December 5, 2017

CWE 2170685.01

**Subject: Update Geotechnical Report and Response to LDR-Geology Cycle 1 Review Memorandum, Proposed Residential Remodel and Single-Family Residences Parcels 1, 2, 4, & 5, Parcel Map 17817, 7727 Lookout Drive, La Jolla, California**

## SITE PLAN AND GEOTECHNICAL MAP

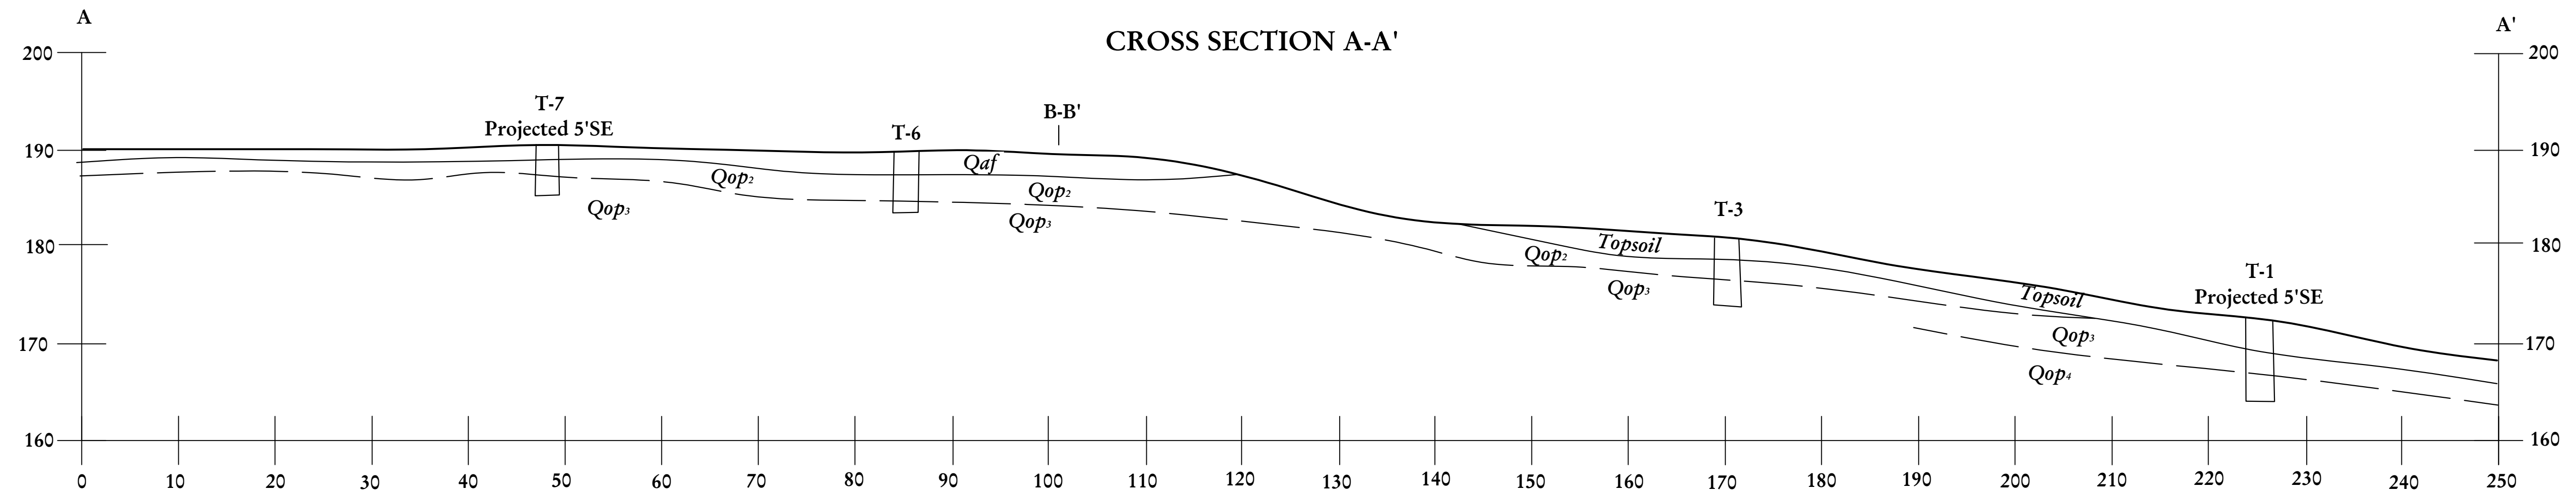
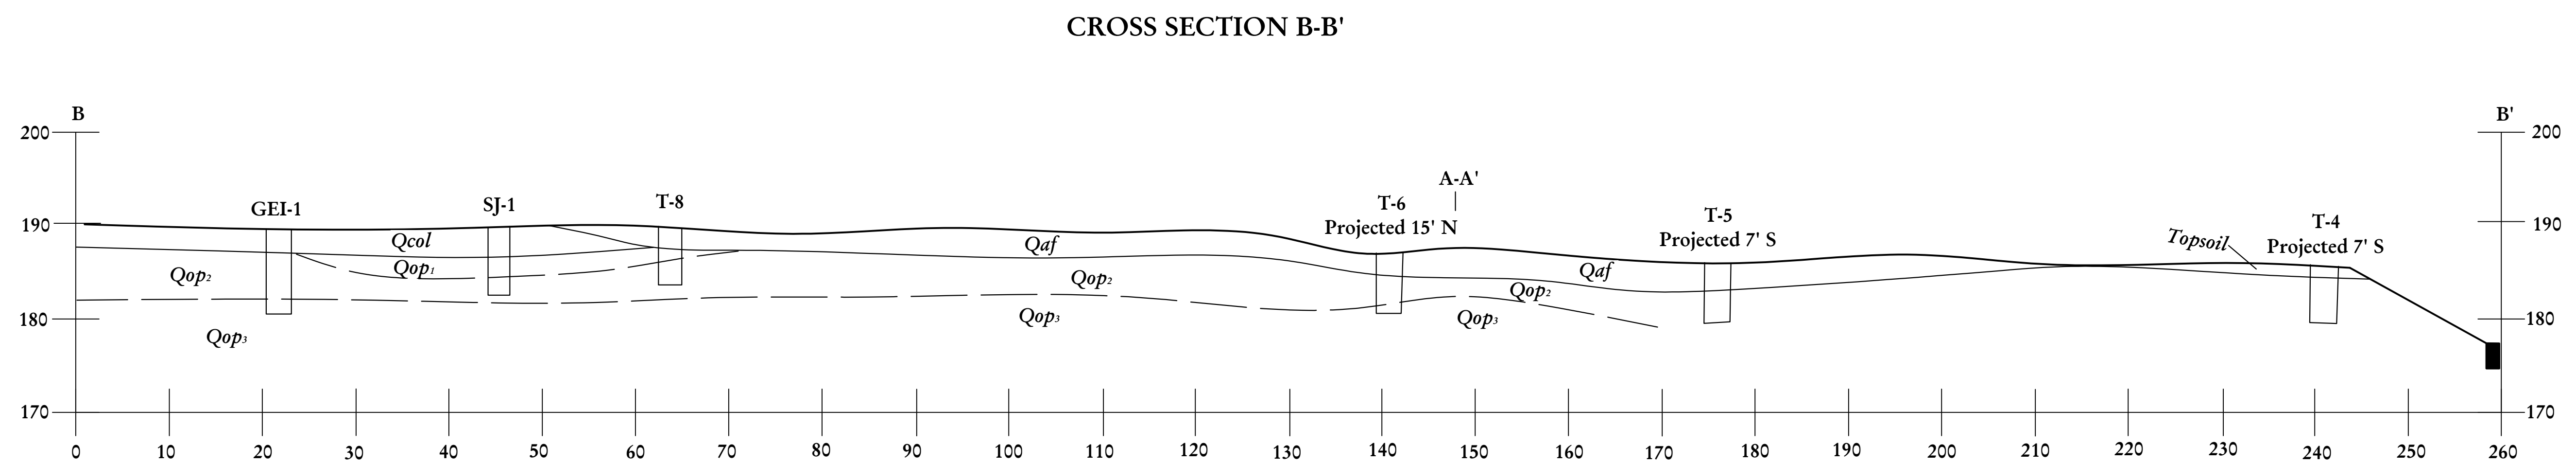
**City Issue #6 – Provide geologic cross sections that correlate the stratigraphy exposed in the geologic/fault investigations performed at the site. Indicate if stratigraphic continuity exists across the site.**

CWE Response – Stratigraphic continuity across the project site. Plate No. 2 of this report presents geologic cross sections A-A' and B-B', which correlate the stratigraphy exposed in the geologic/fault investigations performed at the site. The locations of these cross sections are shown on Plate No. 1 of this report.
